**LEGAL ADVERTISEMENT
HISTORIC PRESERVATION BOARD
CITY OF PORTLAND
Public comments are taken at all meetings.**

HISTORIC PRESERVATION BOARD AGENDA

**PUBLIC HEARING
PORTLAND CITY HALL PLAZA**

In response to Board comments at the June 7 workshop, the project architects have made a number of revisions to their initial proposal. The revisions are summarized in a cover memo included as Attachment 1. The consultants will be bringing material samples to the meeting. Staff has asked that more detailed wall sections, specifications and final site plan be provided as well.

THIRD & FOURTH FLOOR PLAN

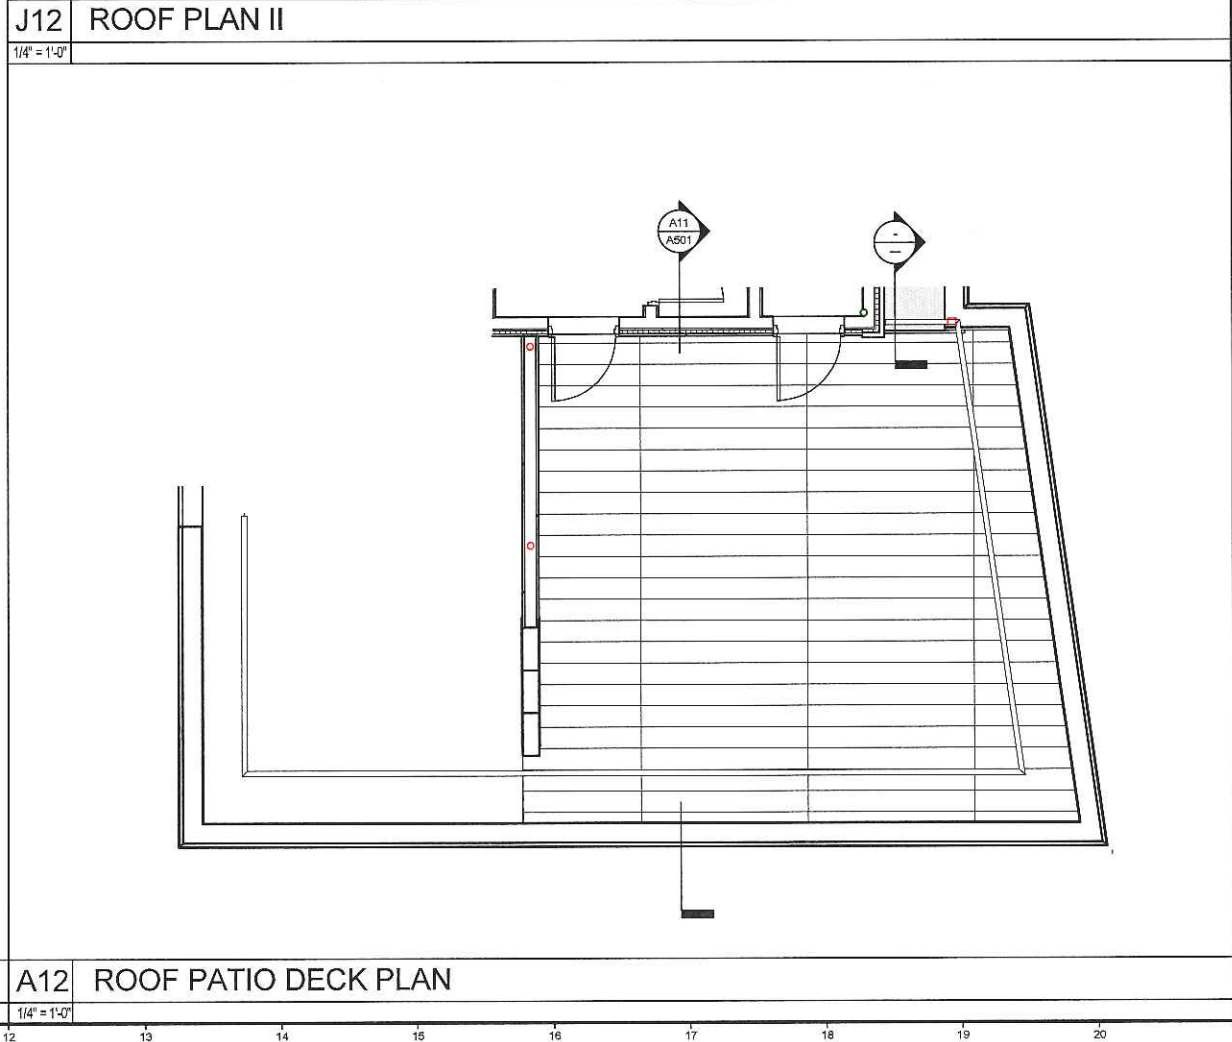
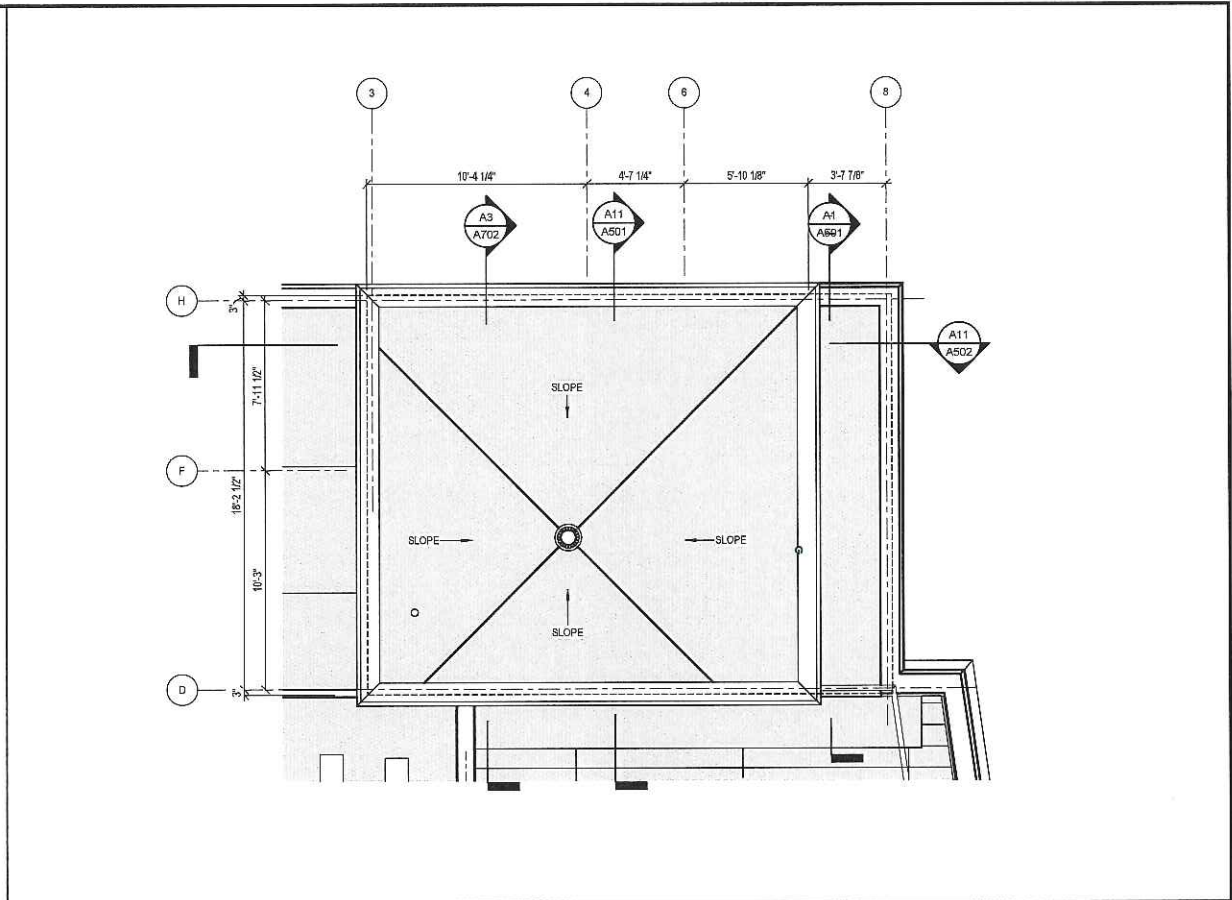
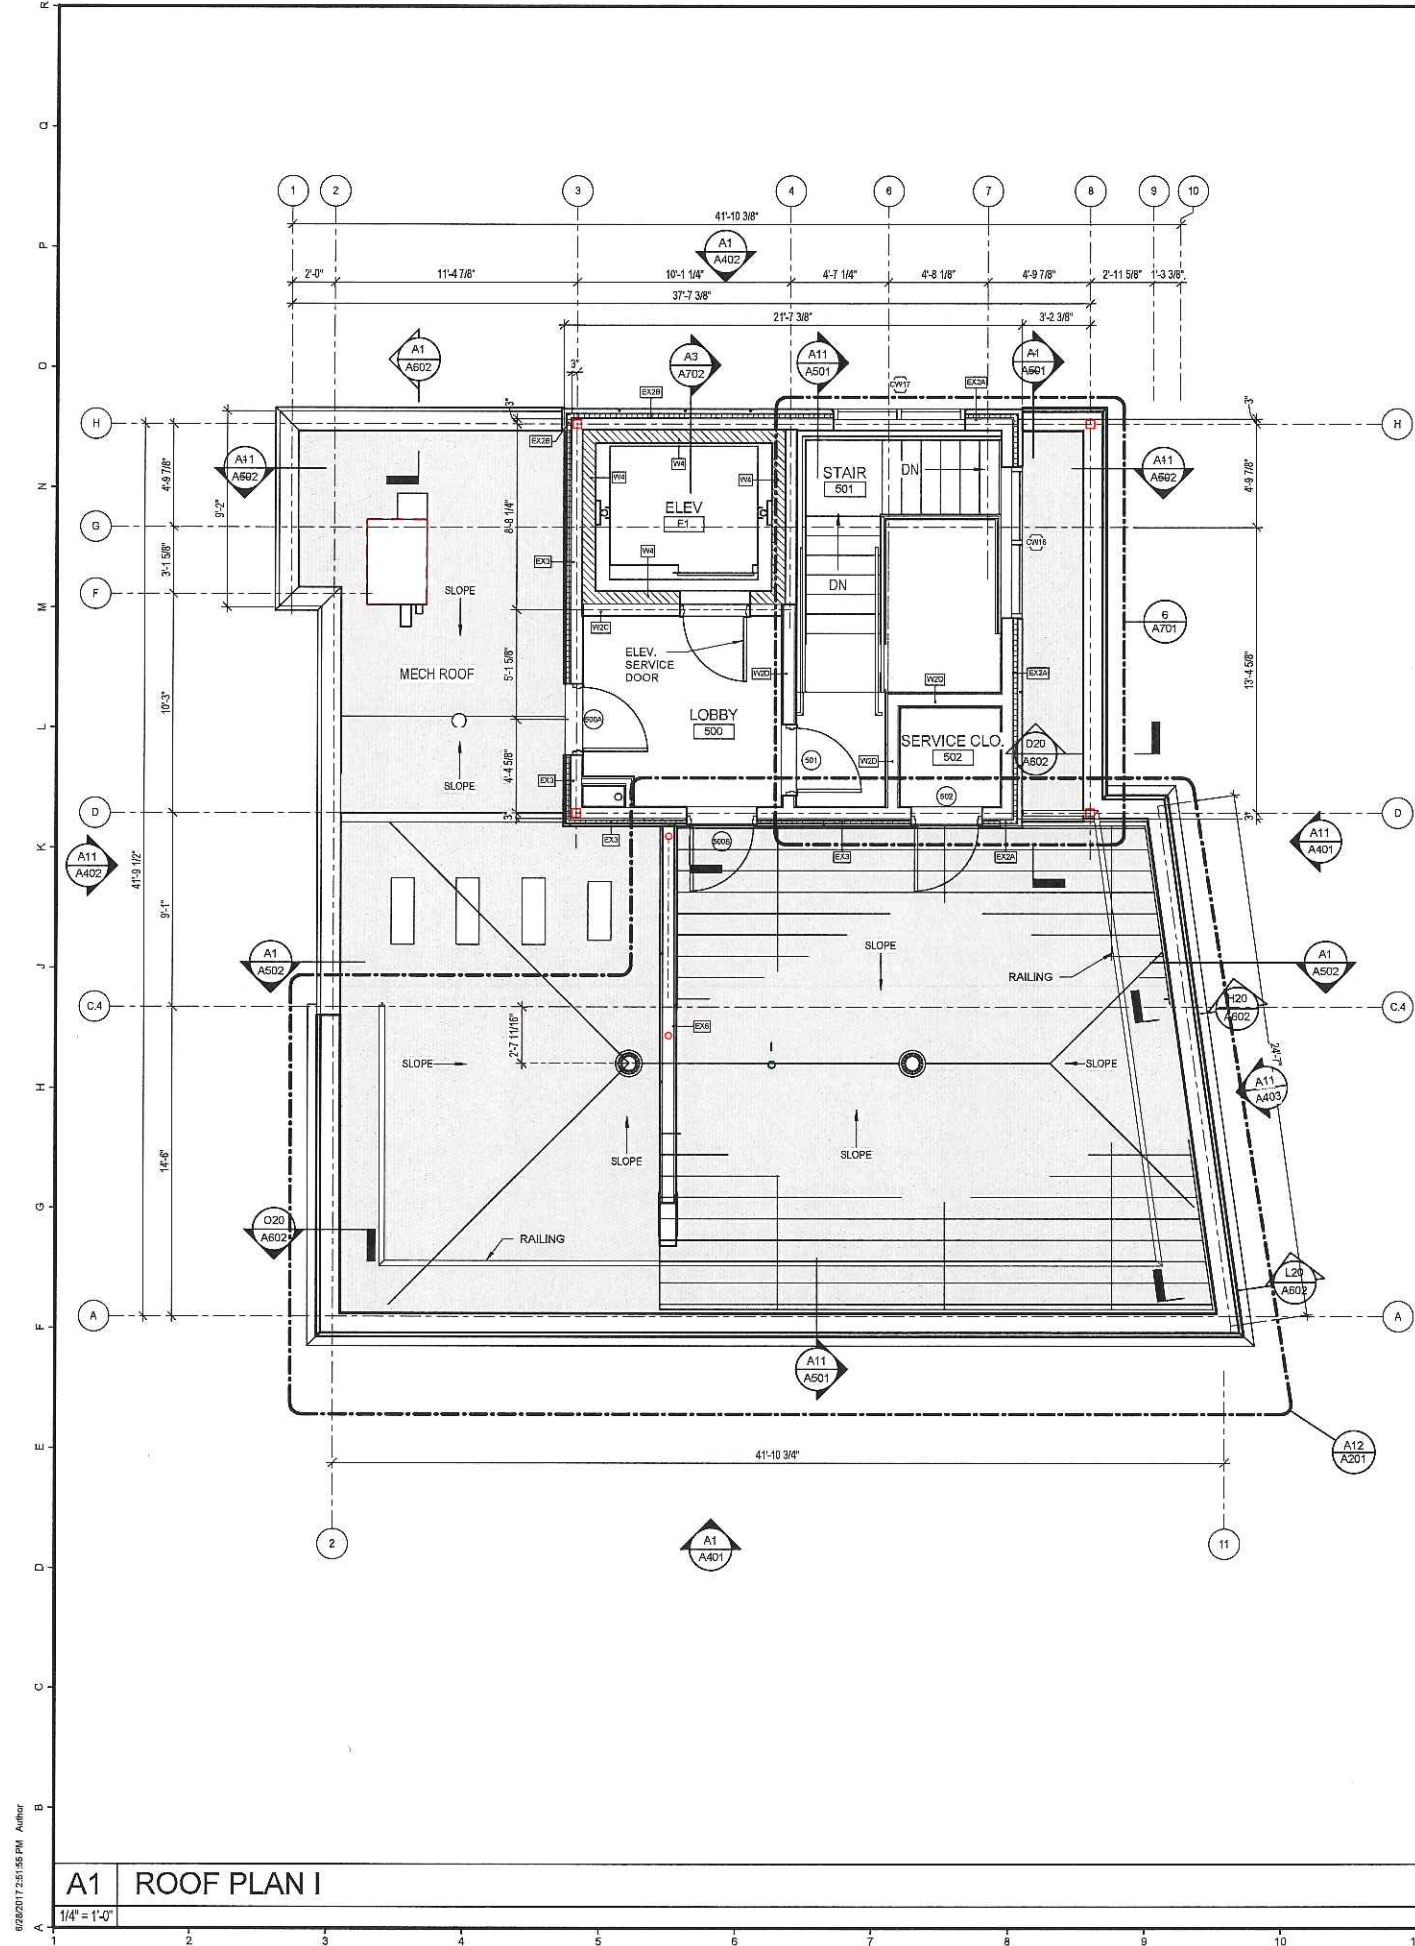
- Questions were raised about the relatively high tonal contrast between the brick and the Alucabond panels on the main block. Board members suggested that a darker finish for the Alucabond would improve the tonal relationship of the upper floor materials.

- Board members expressed concerns about the complexity of the roofline, which featured several projecting elements. Questions were raised about the need to locate the mechanical room at the top of the stair tower and whether the elevator needed to serve the roof deck. Given the prominent corner location of the building, Board members felt it was particularly important that the roofline be unified to the extent possible.

- The "blue" Nichiha ribbed panels have been replaced with gray block panels 18" H x 6' L
- The height of the windows on the fourth floor have been increased by 6" to reduce the height of the alucabond and a corbelled cornice was also added to cap off the top of the building

A401
OPTION B

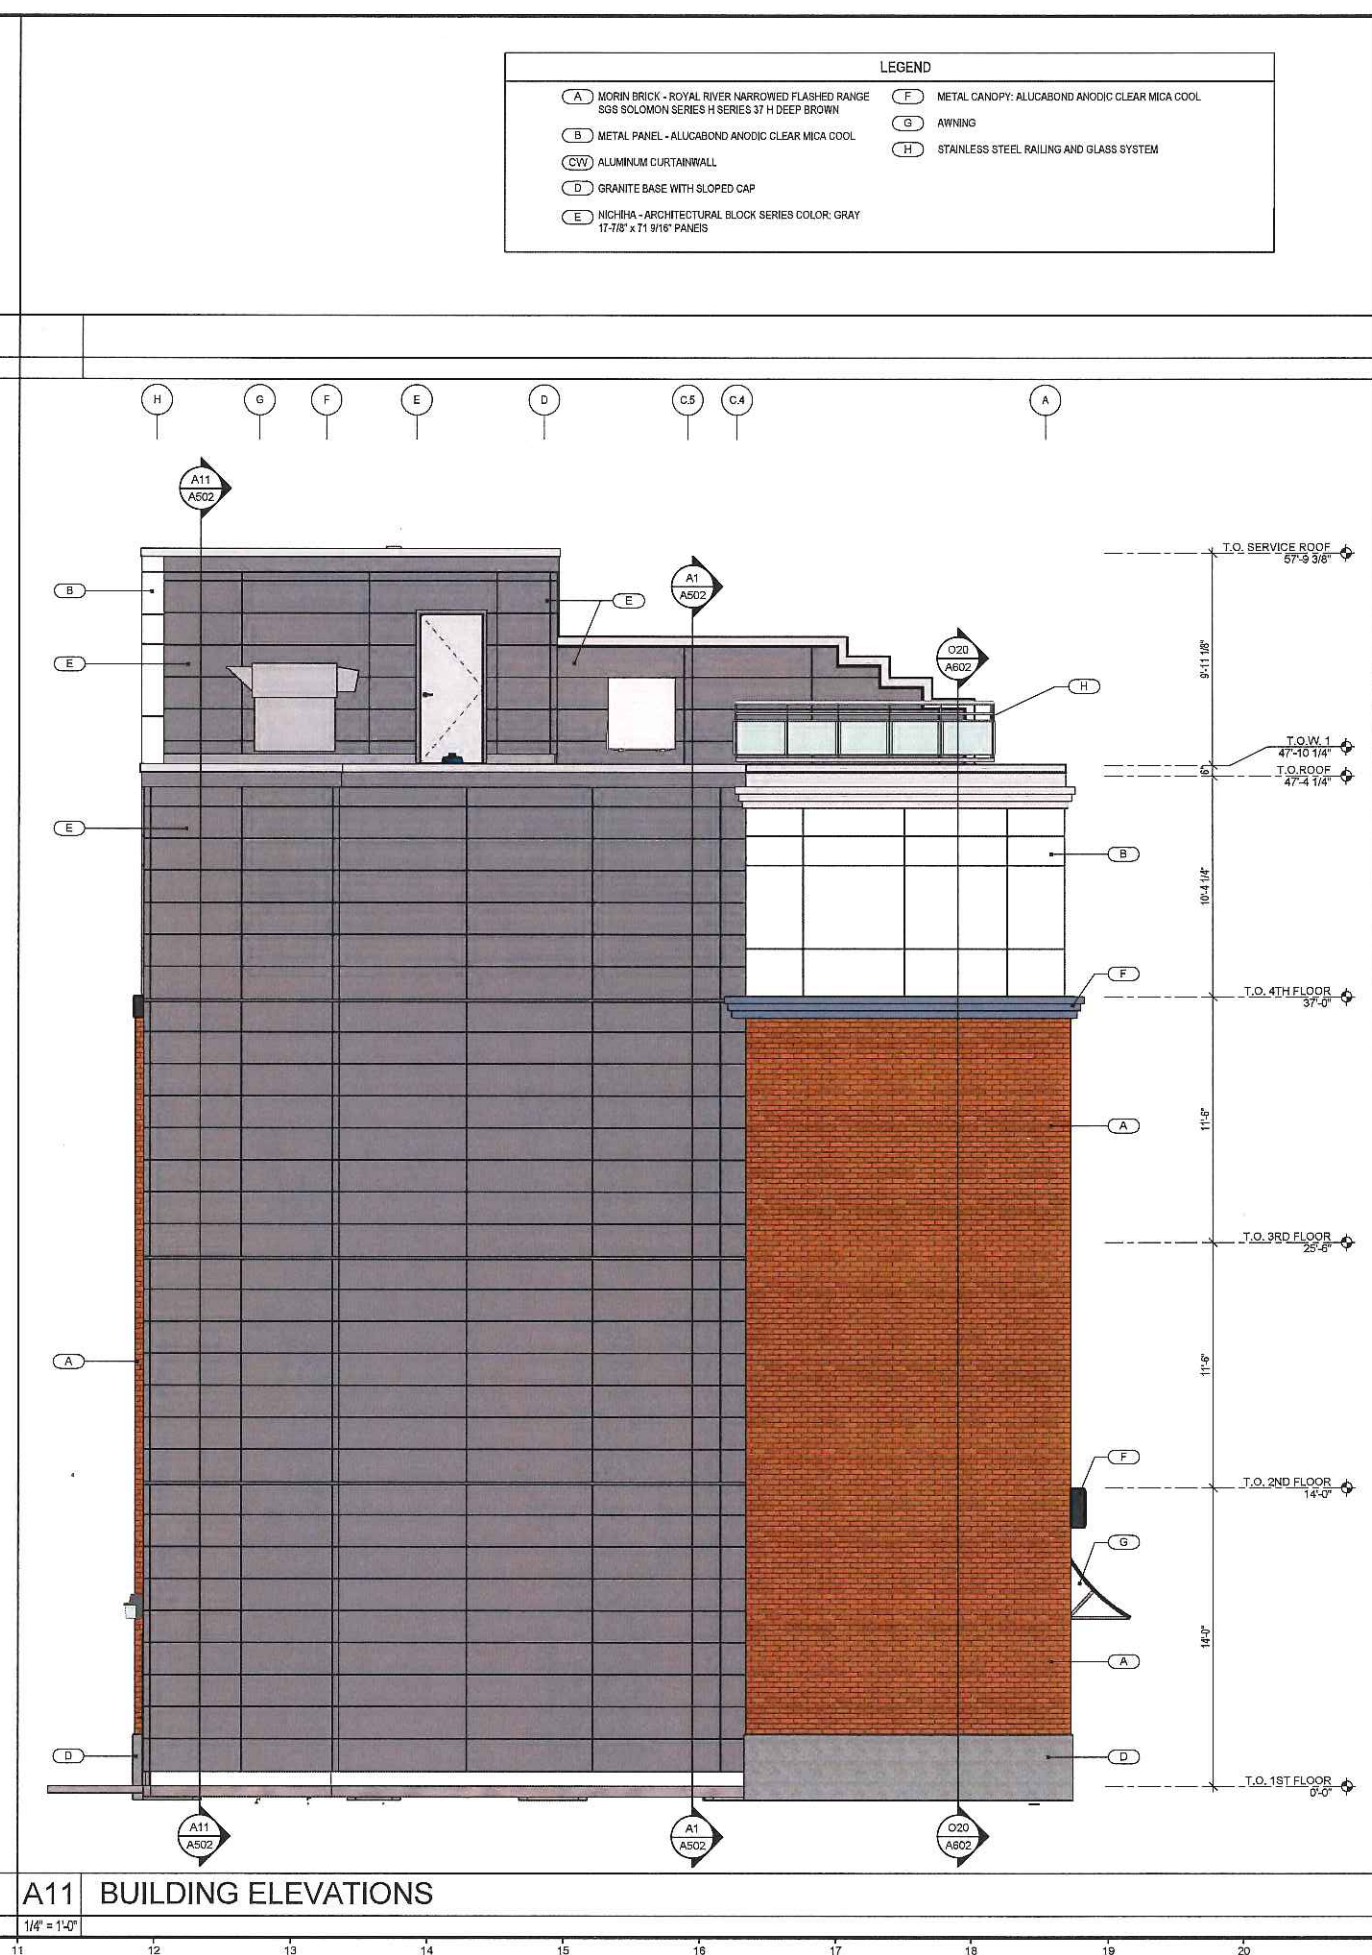
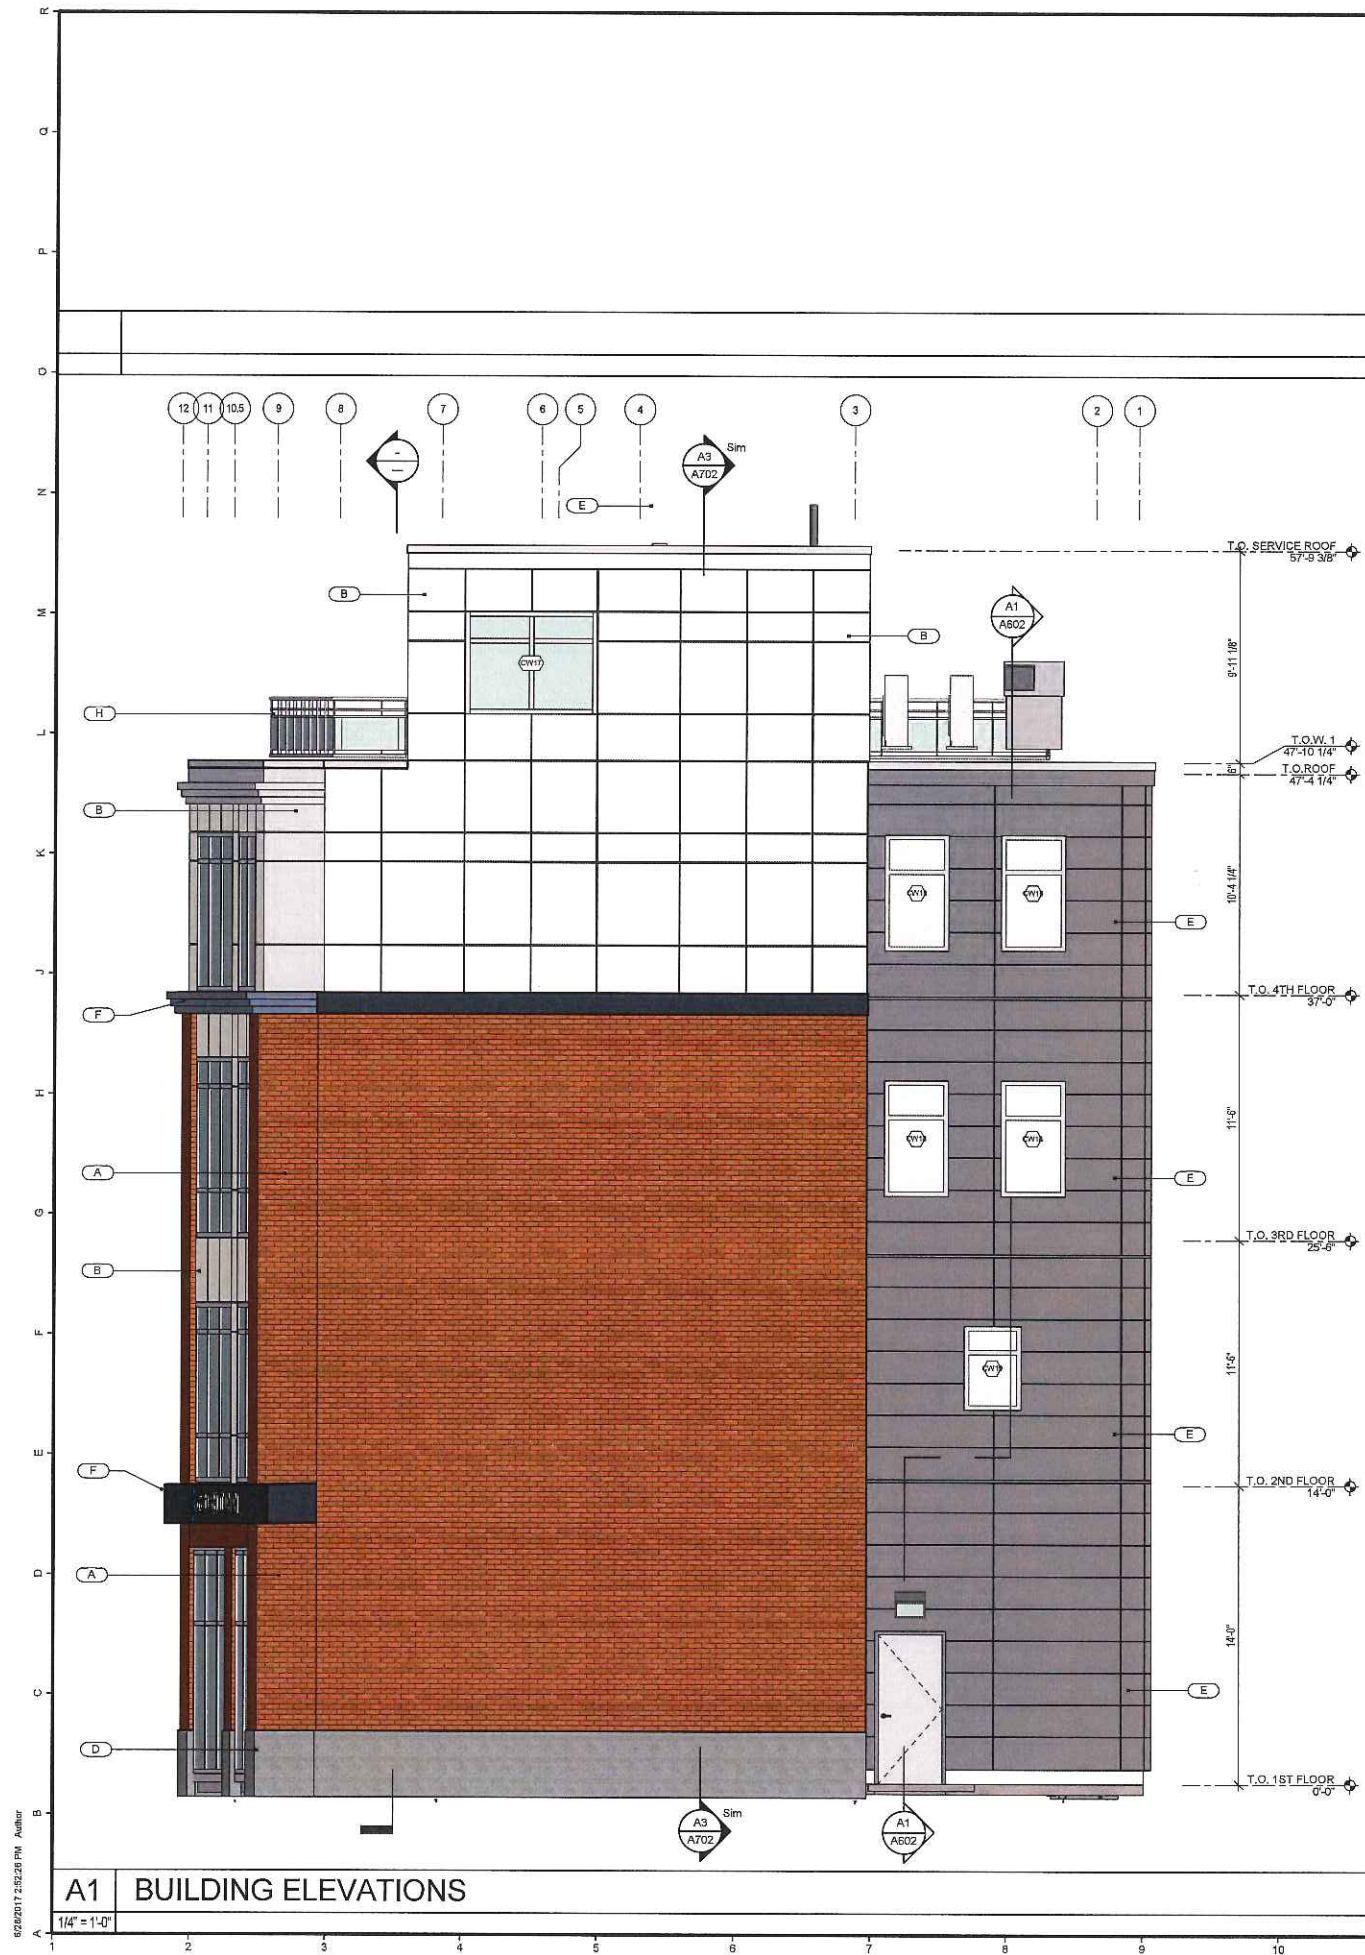
- Project architects were asked whether the interior plan could be flipped, moving the stair/elevator tower to the interior corner. This would allow the residential space on the upper floors to face onto India Street and result in a more cohesive design expression for this elevation.

Although the applicant and project architects have elected to keep the stair tower in its original proposed location next to the India Street sidewalk, the design proposal has been modified in a number of ways in response to Board feedback at the workshop. While not specifically requested by the Board, the architects have carried the architectural vocabulary of the main block onto the India Street elevation of the stair tower portion as well—at all floor levels. (The Board had suggested that the design treatment of the ground floor be continued, but not necessarily that of the upper floors.) Board members will need to determine whether this is necessary or desirable from a design perspective.

- Spandrel glass and windows were added to the stair tower to create visual interest along India Street
- The brick, granite base, alucabond and storefront windows are continued along the entire India Street elevation
